### PLANNING COMMISSION STAFF REPORT

**REQUEST:** The applicant is requesting to partition an approximately 86,358 square foot lot into two parcels per Sweet Home Municipal Code 17.98. Proposed Parcel 1 shall be approximately 11,577 square feet. Proposed Parcel 2 shall be approximately 74,781 square feet, including a flagpole. The subject property is in the Residential Low Density (R-1) zone.

**FILE NUMBER:** P25-07

**PROPERTY LOCATION:** 1247 Clark Mill Road, Sweet Home, OR, 97386; Identified on Linn County Assessor's Map as 13S01E32AA Tax Lot 00500

TENTATIVE  
PARTITION  
PLAN

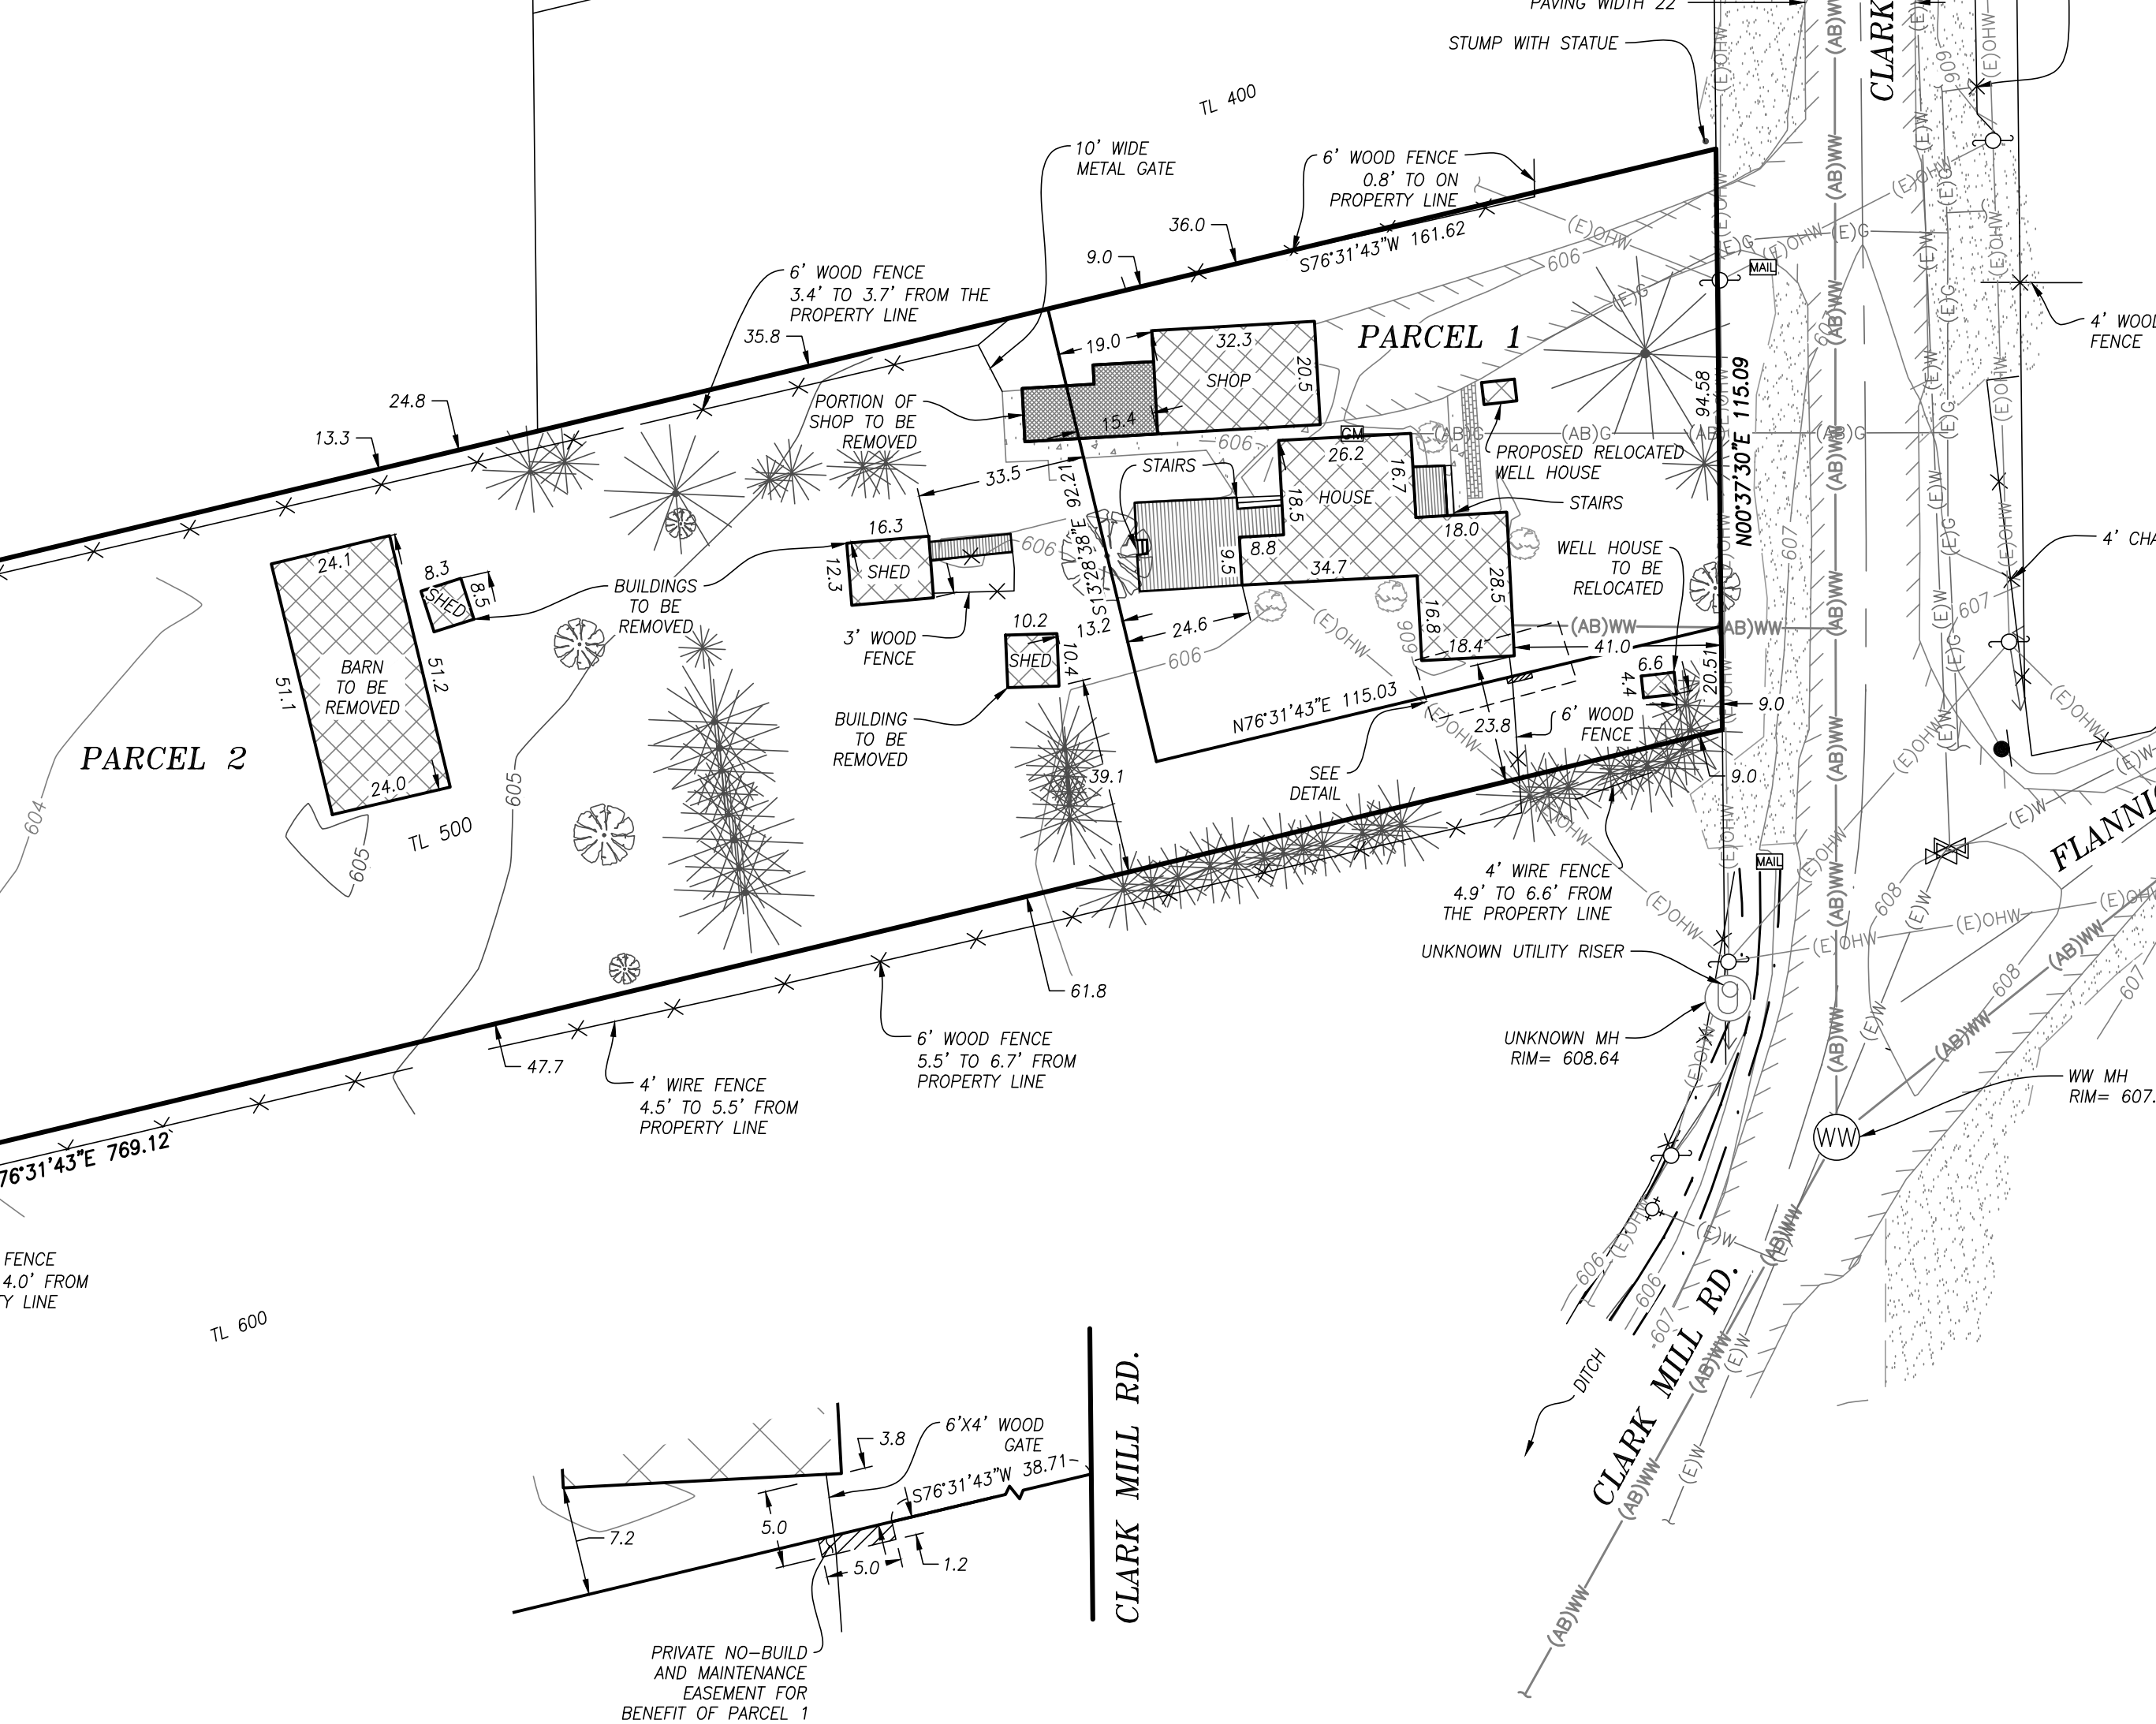
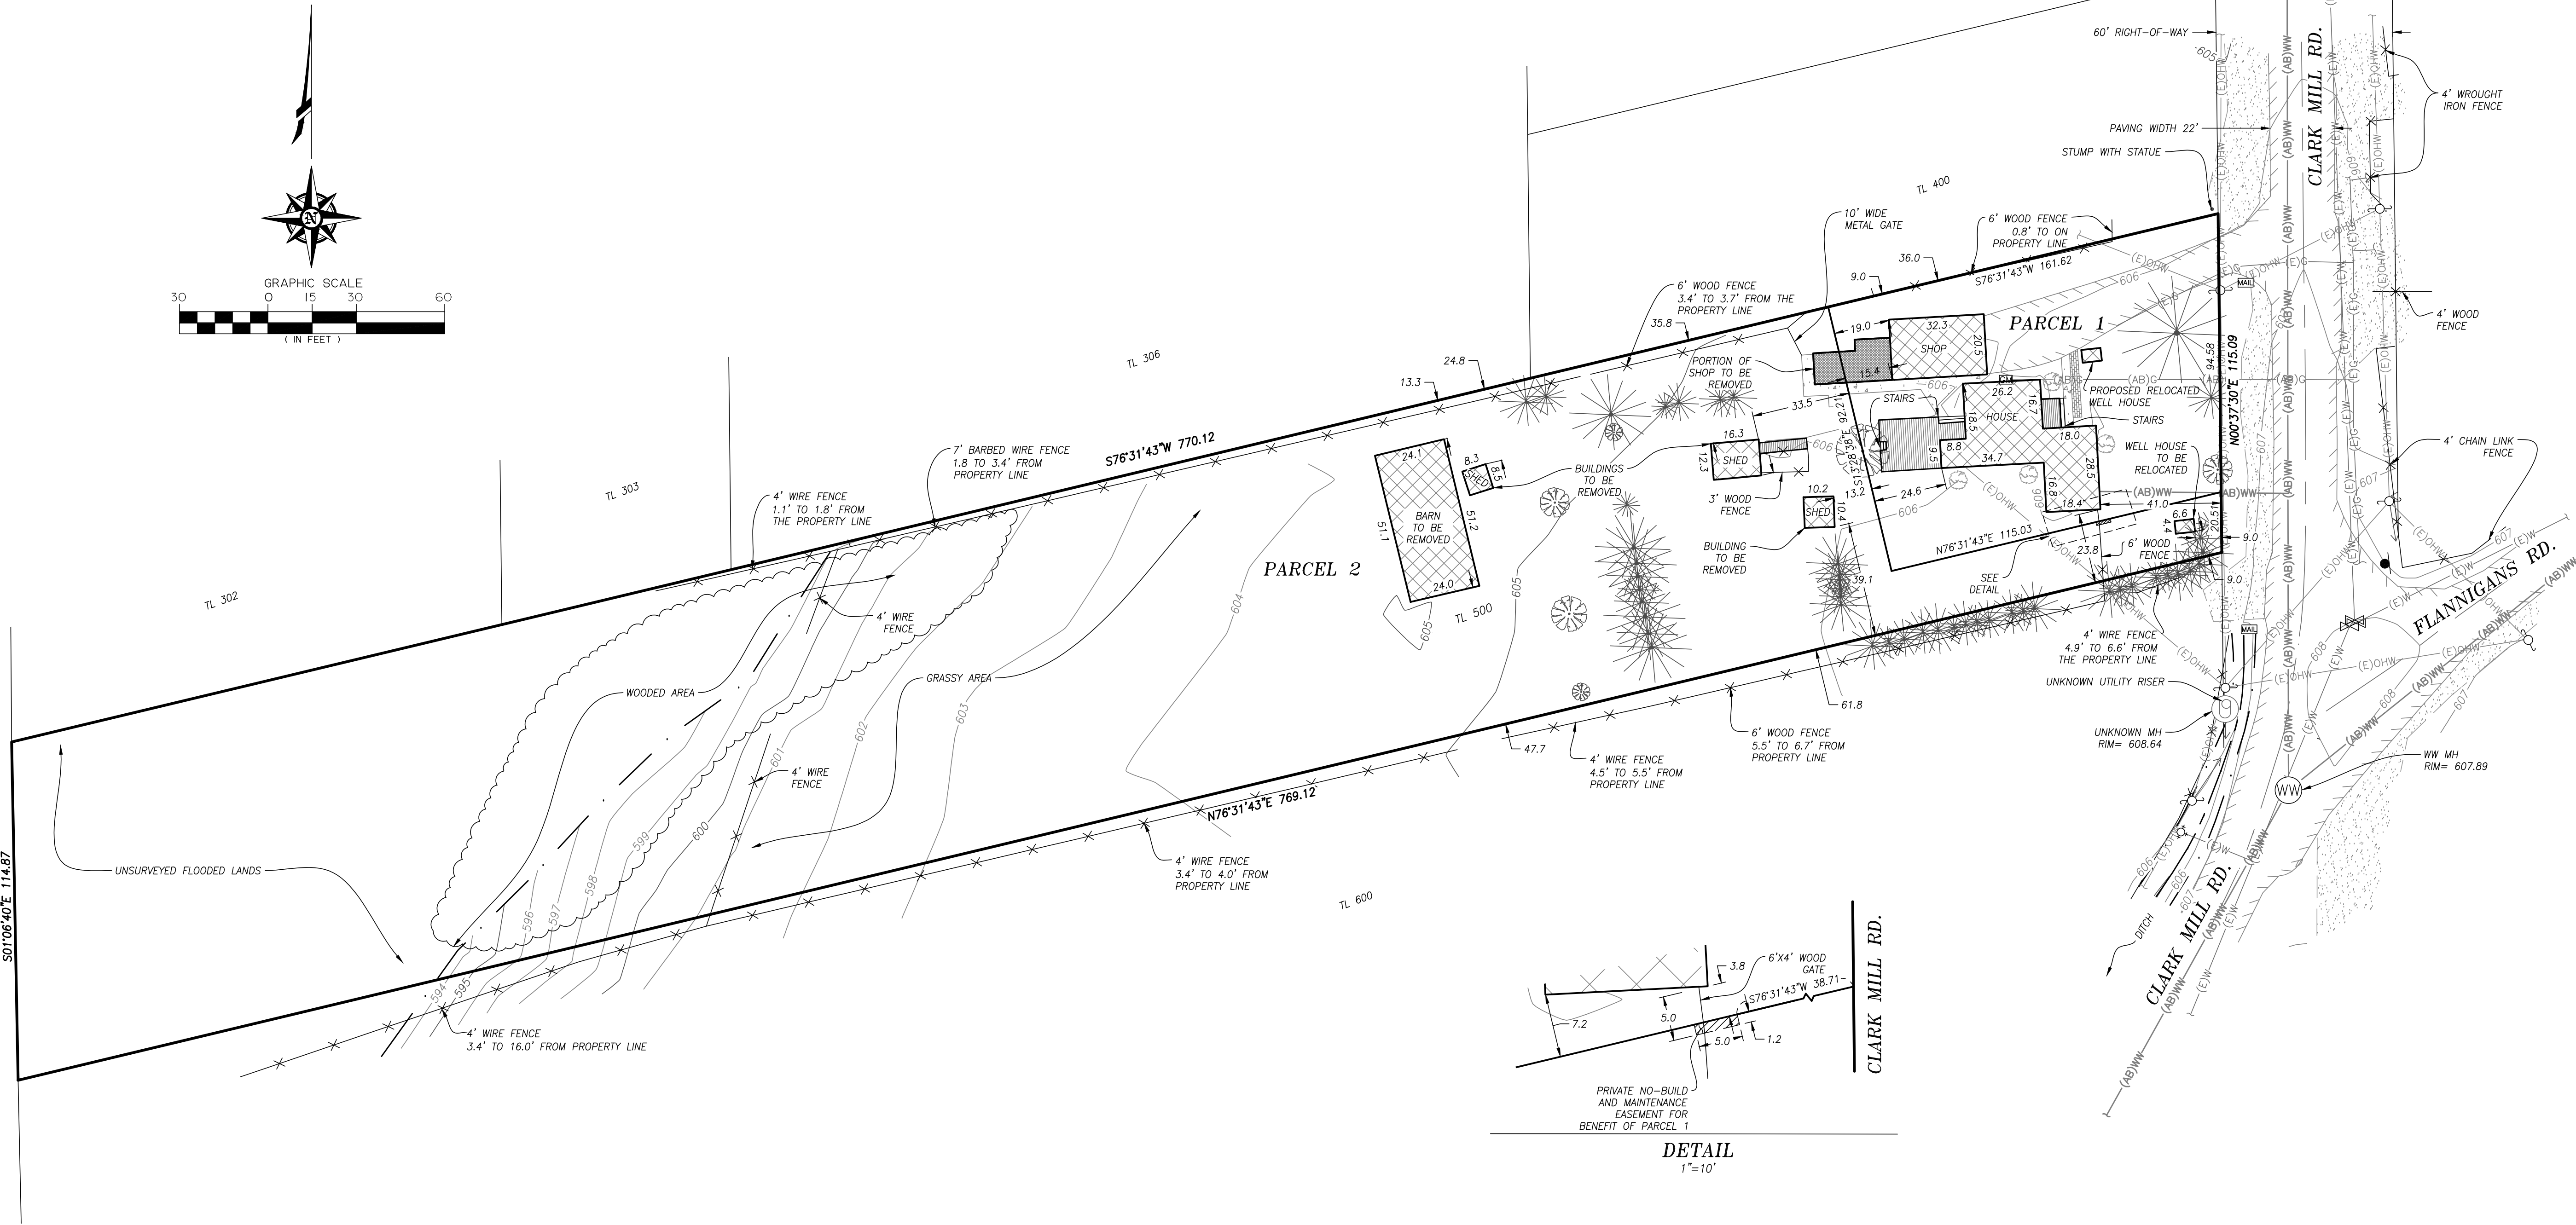
- Proposed Parcel 1 is currently served by existing City utilities.
- Proposed Parcel 2 has access to City water and sewer services located in Clark Mill Road. These services will need to be routed through the flagpole access strip along the southern boundary of Tax Lot 500. The utility easement must be written to benefit both Parcel 1 and Parcel 2.

No development is proposed with this application, and the submitted site plan (Attachment B) does not show utility easements. Staff recommend a condition of approval requiring that all easements be shown on the final plat as well as future site plans. Utility connection costs shall be addressed at the time of building permit review.

Errors were identified on the original site plan, and the applicant submitted a revised plan on September 9, 2025, which has been included in the packet for the Planning Commissioners.

- **Existing Structures on Parcel 1:** Proposed Parcel 1 contains existing structures. As shown on the submitted site plan (Attachment B), the shaded areas shall be removed prior to final plat approval. Once removed, the setbacks shall be approximately:

- Rear: ±15 feet
  - Front: ±41 feet
  - North side: ±9 feetThese front, rear, and north side setbacks comply with R-1 and R-3 standards.
- **South Setback on Parcel 1:** The south setback of Proposed Parcel 1 is approximately 3.8 feet, while the minimum setback for R-1 and R-3 zones is 5 feet. The dwelling is a pre-existing non-conforming structure. Due to the 20-foot width of the flagpole access strip, the applicant cannot fully meet the 5-foot south setback. To address this, a 1.2-foot by 5-foot private no-build and maintenance easement has been included in the flagpole access strip for the benefit of Parcel 1.

Staff recommend a condition of approval that this easement be recorded on the final plat and designated as a no-build area for both Parcels 1 and 2.
